DEVELOPMENT REVIEW BOARD REPORT

MEETING DATE: February 16, 2006

CASE NUMBER/ PROJECT NAME	72-DR-2005 Pima Road Realignment Design		
LOCATION	Pima Road, from the Loop 101 to Deer Valley Road.		
REQUEST	Request approval of site plan, road improvements, wall details/design, and landscape plan for the realignment of Pima Road from Loop 101 (Pima Road) to Deer Valley Road.		
OWNER	City of Scottsdale 480-312-7099	ENGINEER	Entellus 602-244-2566
ARCHITECT/ DESIGNER	Logan Simpson Design 480-967-1343	APPLICANT/ COORDINATOR	Alex McLaren City of Scottsdale 480-312-7099
BACKGROUND	<p>Zoning.</p> <p>As a roadway, there is no applicable zoning. Zoning districts along this roadway segment include I-1, C-2, PNC, R-4, R1-10 and R1-43 all within the ESL overlay.</p> <p>Context.</p> <p>The site is located along the new and existing alignment of Pima Road from the interchange with the Loop 101 freeway north to Thompson Peak Parkway. Roughly 60% of the frontage of this roadway is currently developed with low to medium density residential neighborhoods and a retail center. The remaining 40% is vacant land that will be built with retail, office and industrial uses in the future.</p> <p>As the road passe

SOUND BARRIER CROSS-SECTION:
Pima Road -
from Loop 101 to Deer Valley

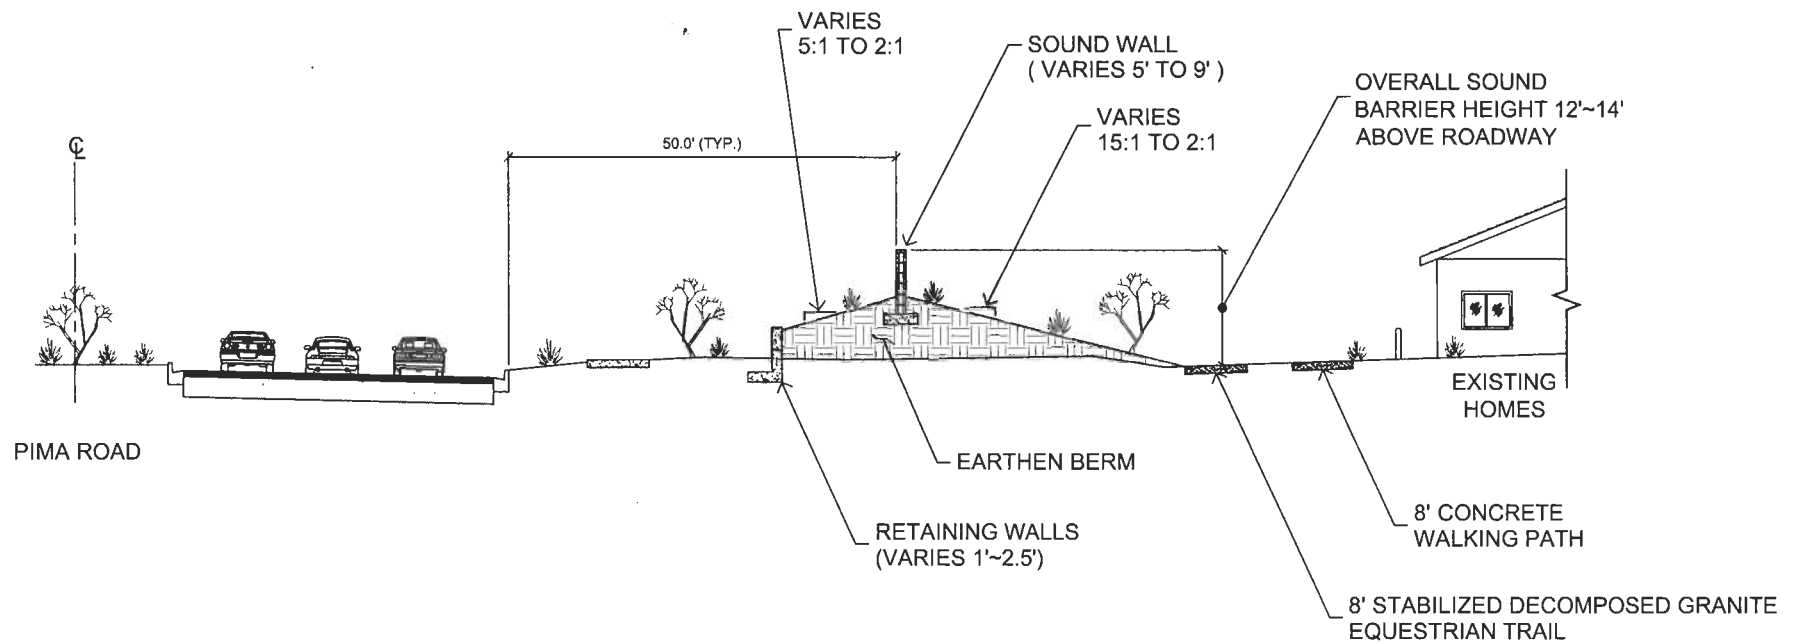
This application reflects the outcome of this very extensive process, particularly regarding the noise attenuation system along the Ironwood Village neighborhoods. This solution uses a combination of berms and walls to achieve the height and proximity to the road needed to achieve the desired noise reduction. The scenic corridor width along this frontage was not wide enough to do the attenuation with a berm and a wall would have been dominating over the roadway as well as the neighboring homes. The solution uses a berm that rises with a low retaining wall of stone and then a landscaped slope on the roadside and landscaped slopes on the neighborhood side. This berm is topped with a 6-foot tall stuccoed wall. This achieves the height needed to reduce the road noise yet includes landscaping that reduces the visual impact of the "hard" surfaces. As Pima Road approaches Hualapai Road this wall and berm system will be designed to blend into the existing sound wall along the Pima Acres subdivision to the north.

The singular key issue is the noise attenuation system for the Ironwood Village neighborhood. Although it will tie into an existing sound wall to the north, this should be considered as an exception to scenic corridor treatments. The relocation of a major roadway next to existing homes created a situation that required unique solutions in order to achieve a mutually acceptable solution.

PEDESTRIAN BRIDGE
Pima Road
from Loop 101 to Deer Valley

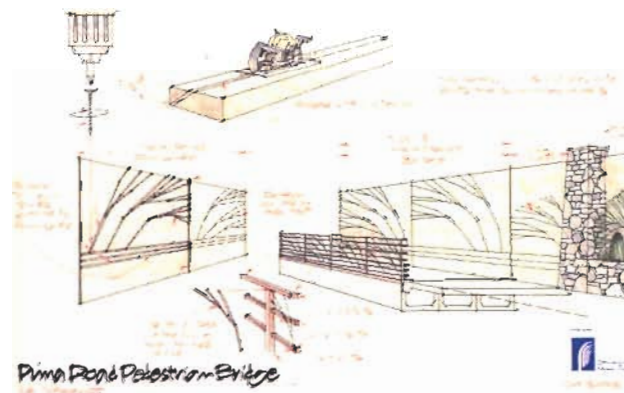
Where the road crosses a large drainage channel coming out of the Ironwood development, a unique solution has been proposed. The existing bridges will be reconfigured to handle the road lanes and no room will be left for the pedestrian walk along the road. Therefore, a new pedestrian bridge will be installed east of the existing bridges. This bridge will have a concrete wall on its west side that will provide the noise buffering and a metal railing on the east side. This wall and railing will be patterned with a design that evokes the image of Palo Verde tree branches.
